Service Bulletin

Subject: Unable To Connect High Voltage Cable To Replacement Accessory DC Power Control Module (APM)

Models: 2011-2013 Chevrolet Volt

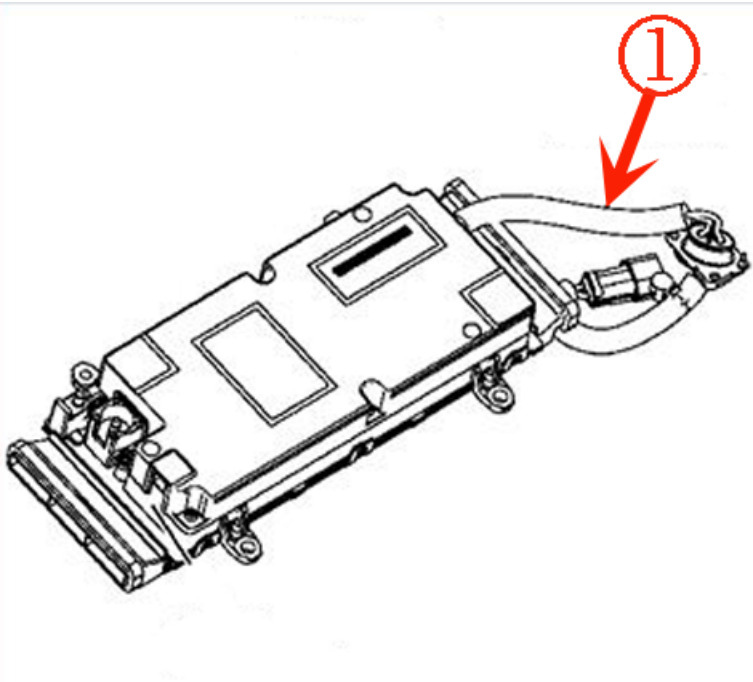
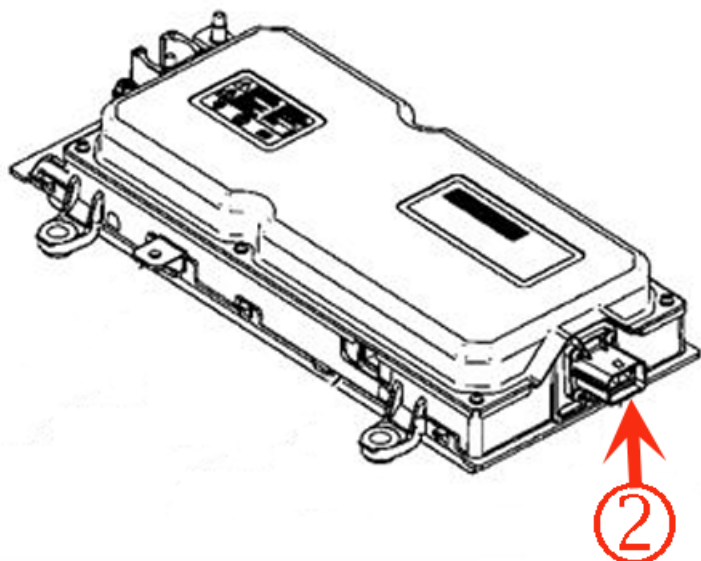
Certain 2011-2013 Chevrolet Volts were equipped with a first design APM which has a 24 inch orange pigtail attached to the module and there is no high voltage connection right at the module itself (See Photo Below)

When replacing the APM with a new service part APM, you will notice that the new part has no pigtail and the high voltage connection is right at the module itself (See Photo Below)

If your vehicle has a first design module and you are replacing the APM , an additional jumper harness (GM Part Number 24268507) will need to be installed. An instruction sheet will be provided with the jumper harness kit on how to install the new design module. If the jumper harness instructions were not included with the new part, please contact the Technical Assistance Center for a copy of the instruction sheet.
